NC20920 – B3 Visual Review

Feedback on Vacuum Vessel support pads per request of weekly quality meeting.

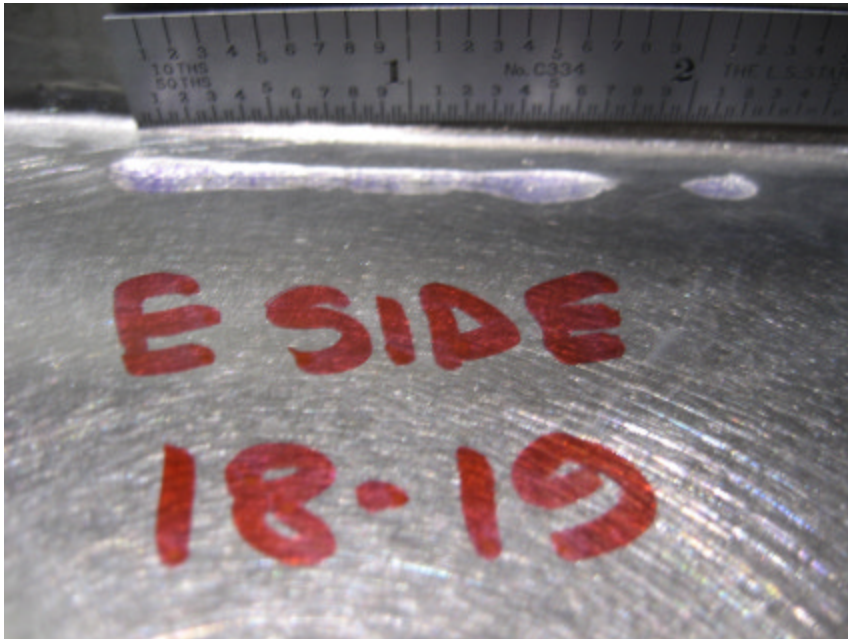
Tool Gouges on E side Long Leg near radius

Tool Gouges on E side Long Leg near radius

.400" distance from short leg to
VPI groove (sheet 2, zone G7)

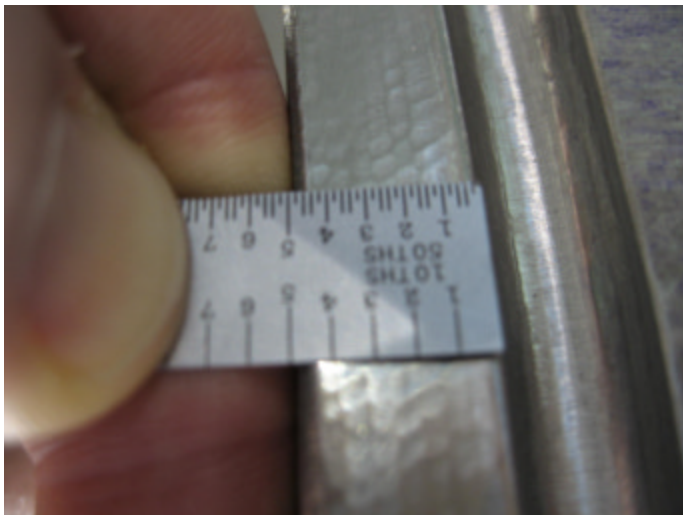
There is an area on the Datum D side from T
hole 81 to 86 that checks as small as .300".
The transition has been blended smooth.

There is an area on the Datum D side from T
hole 70 to 73 that checks as large as .506".

(SEE NC20917 step 110)

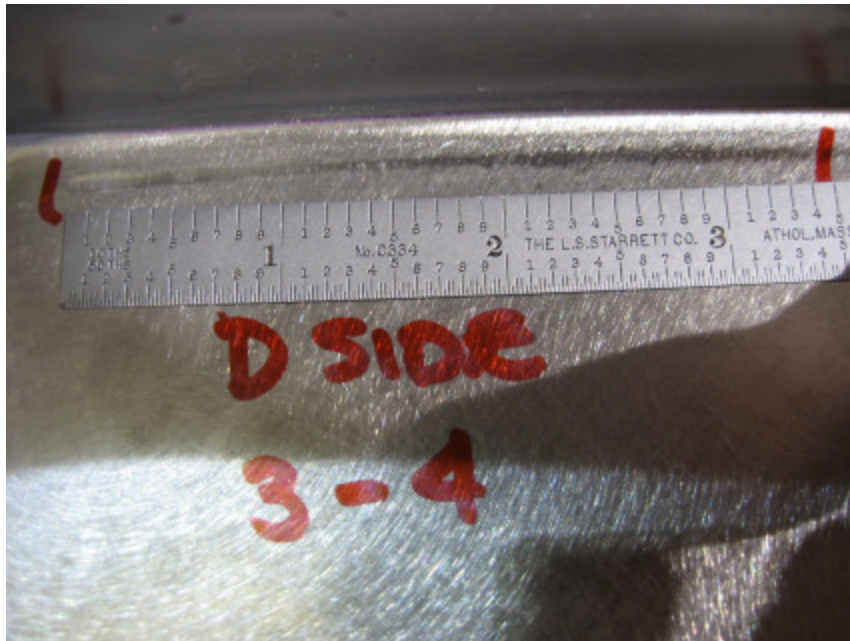
Tool Gouges on D side Long Leg near radius

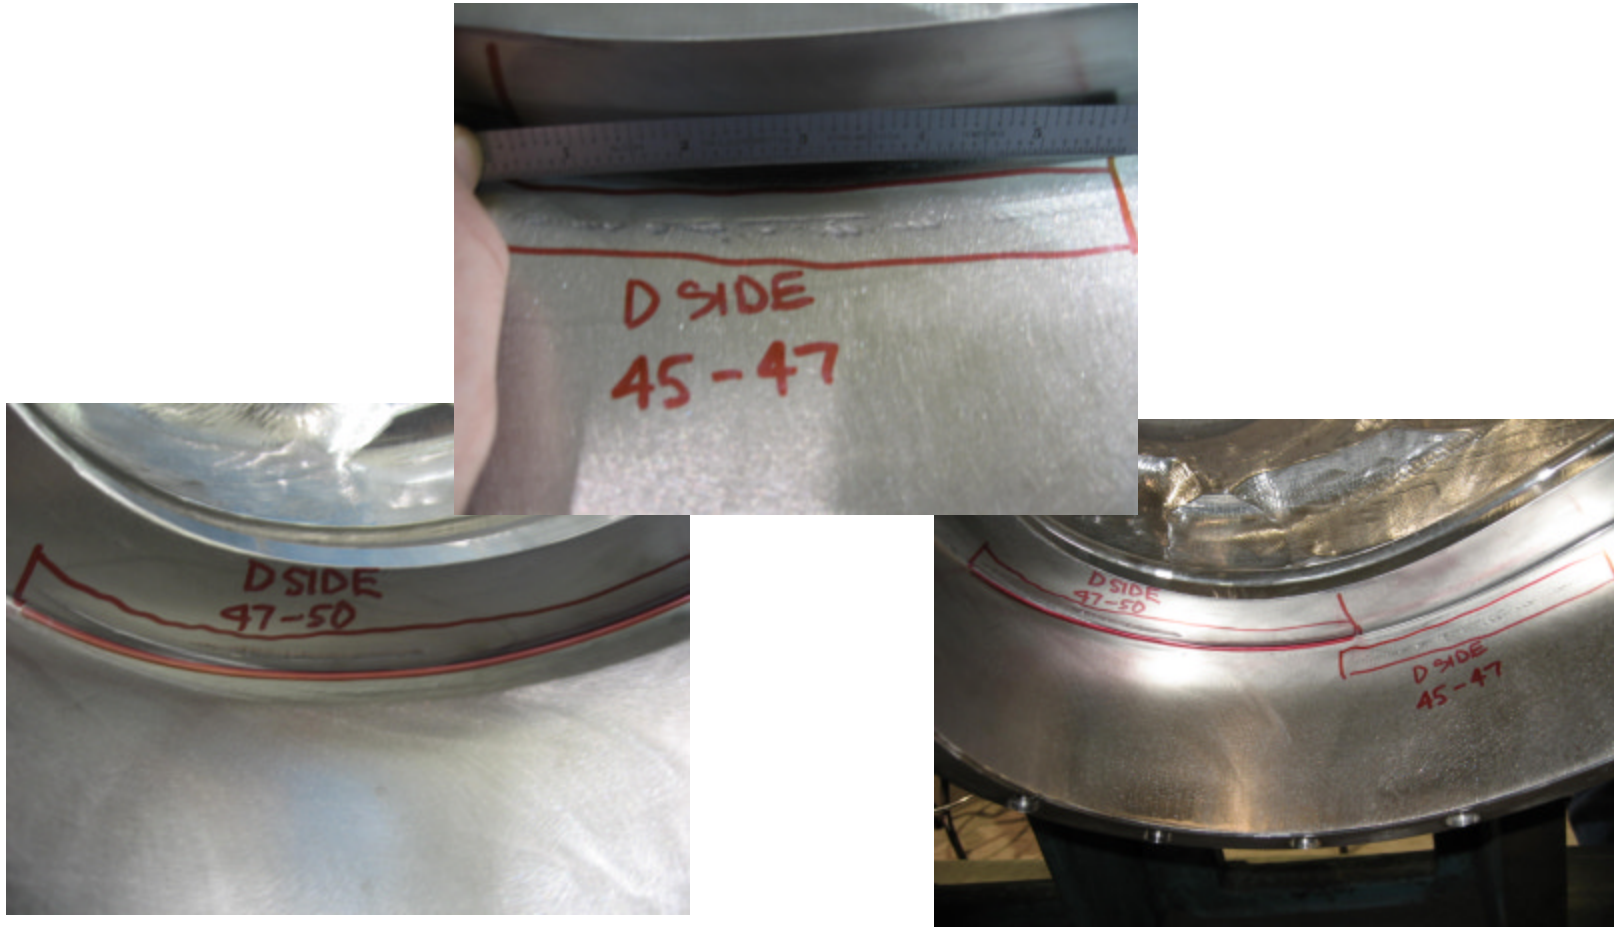
Tool Gouges on D side Long and Short Legs near radius

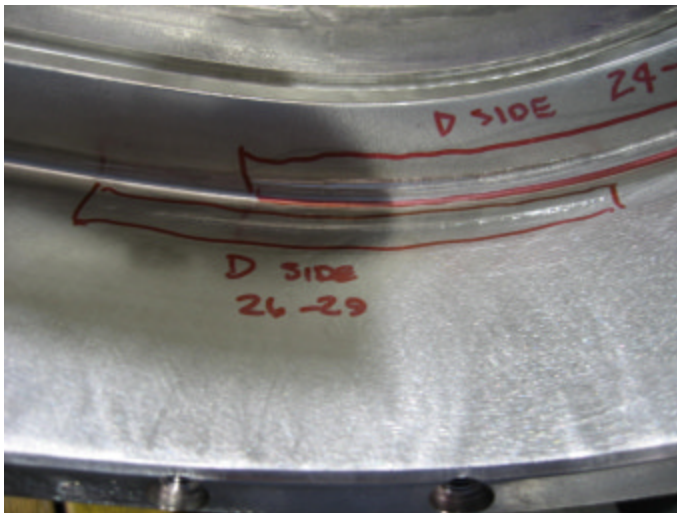
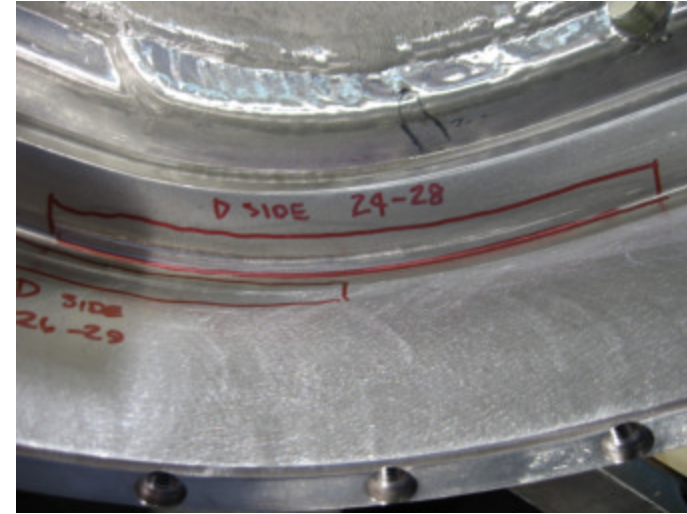
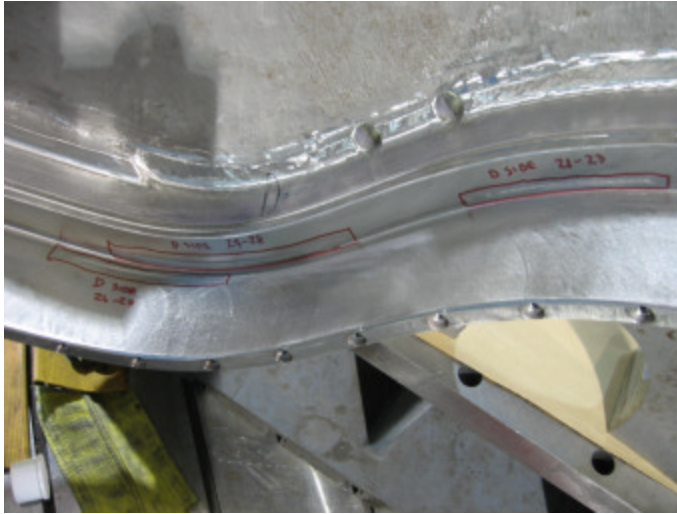
Tool Gouges on D side Long and Short Legs near radius

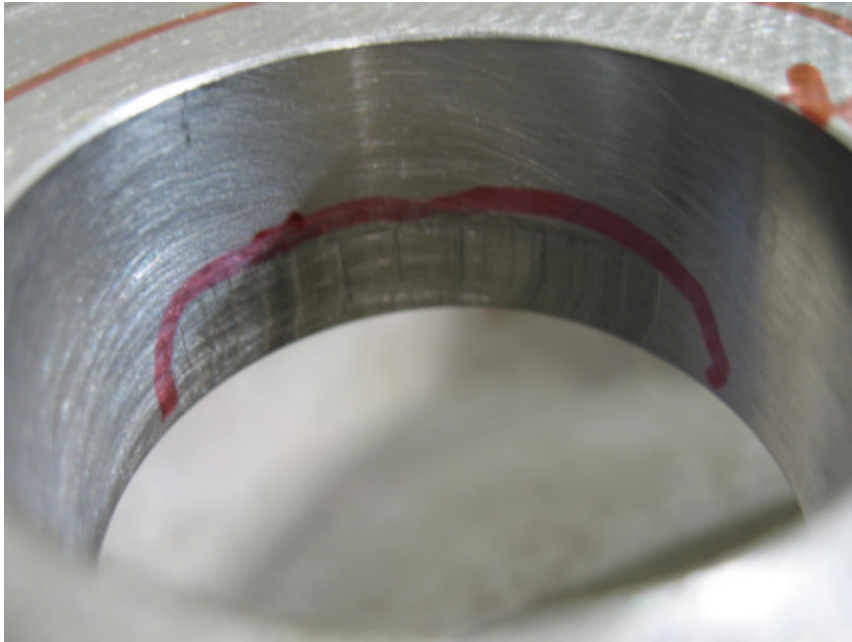
Oversize area in hole #27 in
Datum E flange. (reported
on NC20917 step 730)

Undercut areas adjacent to .12" radius of Long Leg

Datum E Side

E93 – E4 (.010" - .017")

E53 – E55 (.010" - .011")

Datum D Side

D42 – D45 (.010" - .024")

D58 – D60 (.010" - .011")

D62 – D66 (.010" - .015")

D73 – D75 (.010" - .025")

D84 – D88 (.010" - .022")

The picture to the left is of the port opening on the Datum D flange just beneath the Lead Block pad.

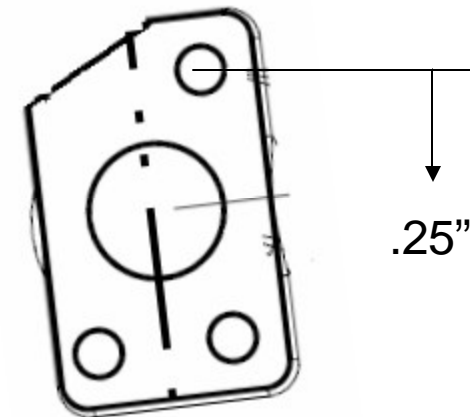
A programming error resulted in too much material being removed during the rough machining operation. An area on both sides of the port did not clean up.

One area measures approximately .25" x .25" and the other is .35" x .35". Both cutter marks extend through the opening the thickness of the casting wall.

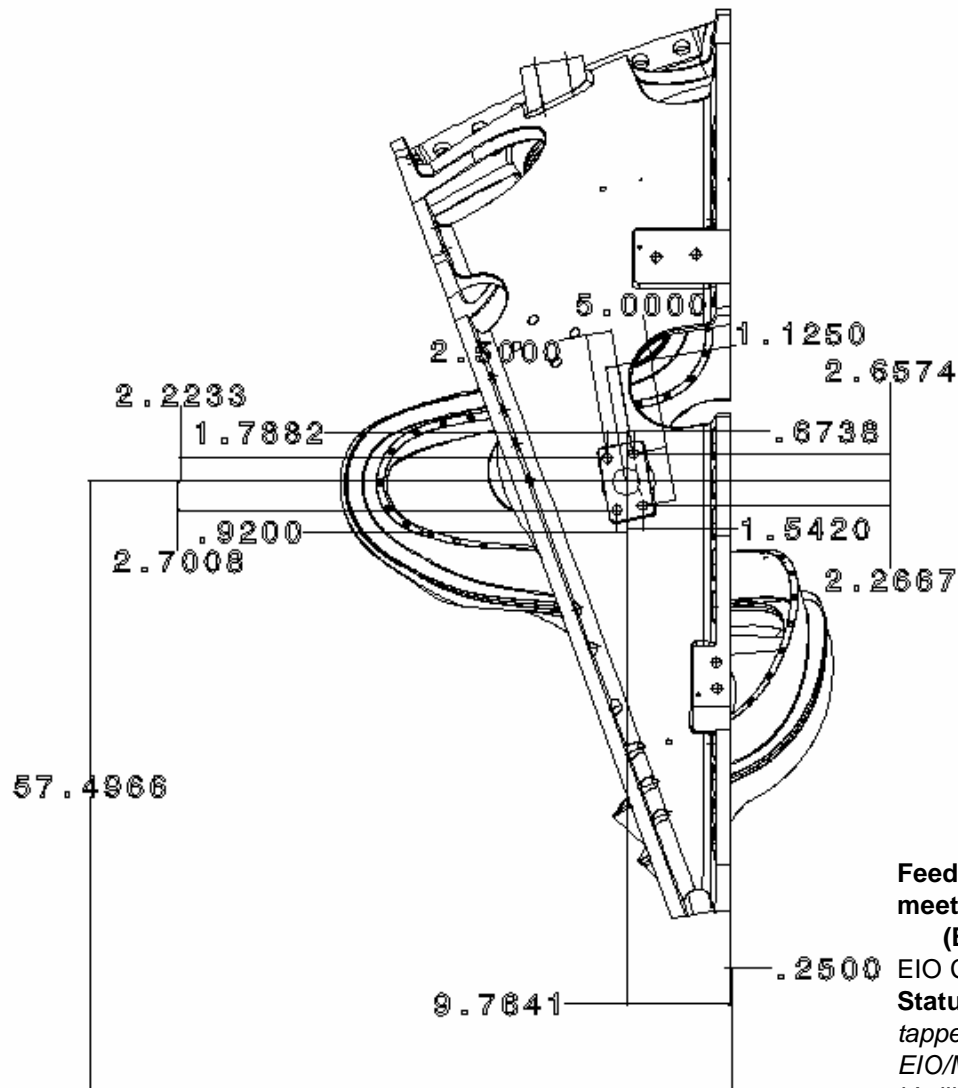
From the orientation shown, the 1-8" hole pattern was shifted .25" down. This hole pattern, per the model, was not centered about the 2.5" hole prior to this shift.

(EIO, MTM) Provide documentation of completion of corrective action for EIO CA 090606(NCR) for B-3 & B-6 Vacuum Vessel support pads deviations.

Status: (Open) MTM confirms that the center hole position is fixed but the tapped hole pattern is being shifted as needed (applies to all Type B castings). EIO/MTM will provide proposed shifted locations prior to drilling. On B3 & B6 it's likely that one hole cannot be drilled (corner missing). The CA will remain open until after B6 is completed.
